PROJECT: Summerlin West V25 - Scurry Bend Drive Improvements

CITY OF LAS VEGAS INTER-OFFICE MEMORANDUM		DATE: June 3, 2021
TO: Land Development Services Department of Building & Safety		FROM: Albert Sung, P.E. Flood Control Project Engineer Department of Public Works
SUBJECT:	Drainage Study for:	COPIES TO:
Summerlin West V25 - Scurry Bend Drive Improvements (from Sunset Run Dr. to Lake Mead Blvd.)		Atkins
Cross Streets:	Scurry Bend Drive. & Lake Mead Boulevard	Howard Hughes Company, LLC
File Number:	F:\Depot\DSMemos\DS5427C.doc	Bart Anderson, P.E., DevCo
Parcel Number:	137-15-801-002 & more	
Zoning Action:	N/A	
FEMA Flood Zone	YES NO X	
Proposed Storm Drain	YES X NO

Addendum #2

**RE: ADDENDUM #2 TECHNICAL DRAINAGE STUDY FOR SUMMERLIN WEST VILLAGE 25
SCURRY BEND DRIVE – SUNSET RUN DRIVE TO LAKE MEAD BOULEVARD**

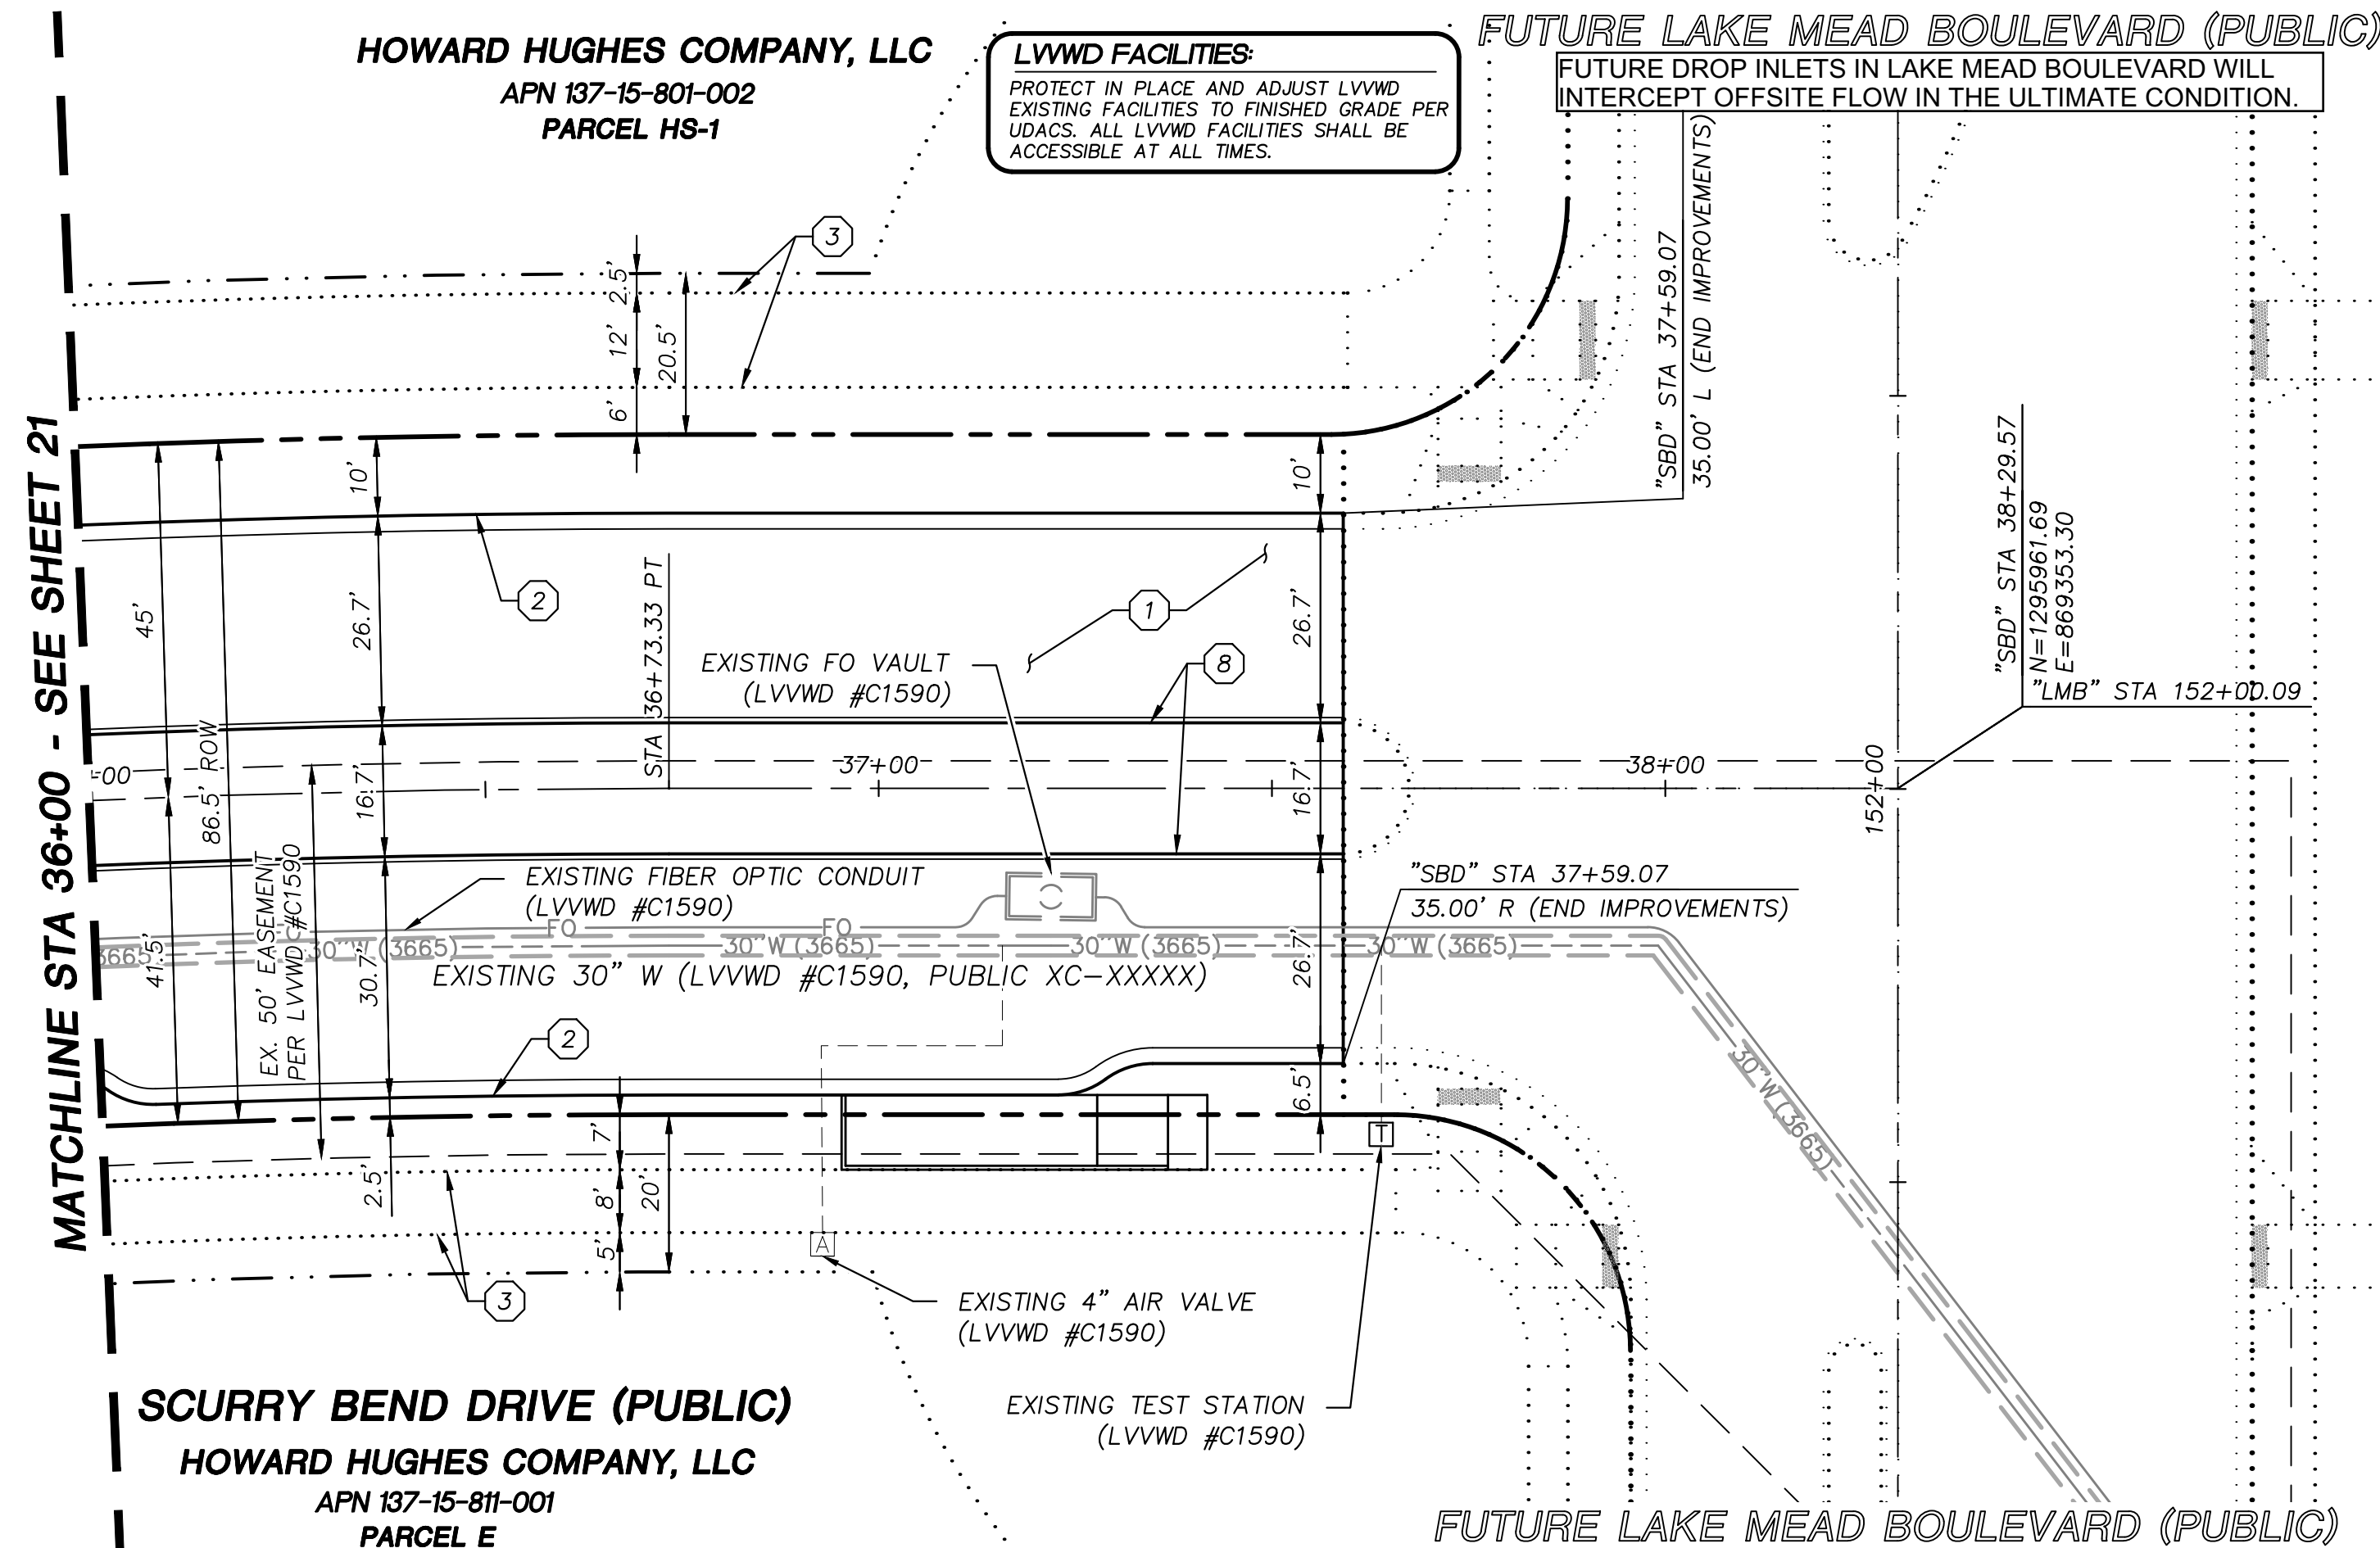
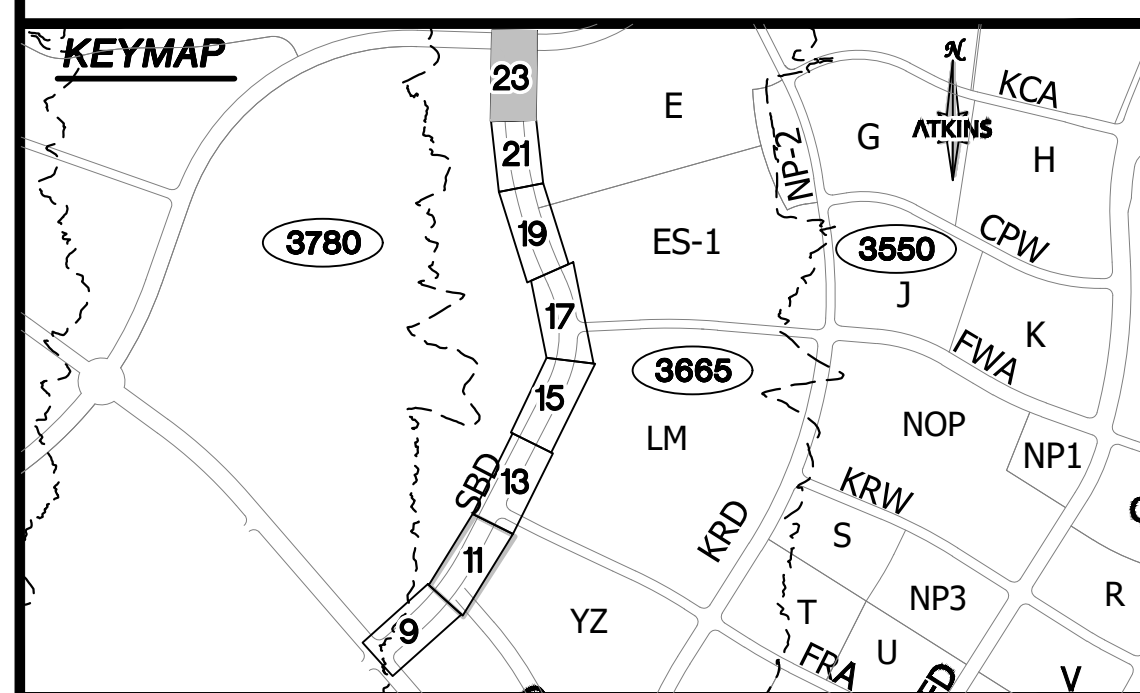
Comment #5: Previous Comment #17: *Sheet 22/42 and Sheet 23/42: Discuss about whether there will be any inlets in the future Lake Mead Boulevard upstream of the intersection with Scurry Bend Drive. If there are none and to meet the 600'-maximum spacing requirement for inlets, the storm drain may need to be extended from SDMH #7 and two nominal inlets be provided in the vicinity of the intersection of the two roadways.*

The response is that there will be a drop inlet in Lake Mead Boulevard upstream of the intersection with Scurry Bend Drive. Show as such in the inlet on sheet 22/42 and Sheet 23/42 as "Future" in the next submittal.

Comment response: The Master Drainage Plan for Lake Mead Boulevard: Kettle Ridge Drive to Scurry Bend Drive was provided in the previous submittal to show the prop inlets that will be provided to collect flow in Lake Mead Boulevard. A note has been added to the Scurry Bend Drive improvement plans referencing the Future Drop Inlets on Lake Mead Boulevard that will intercept offsite flow in the Ultimate condition.
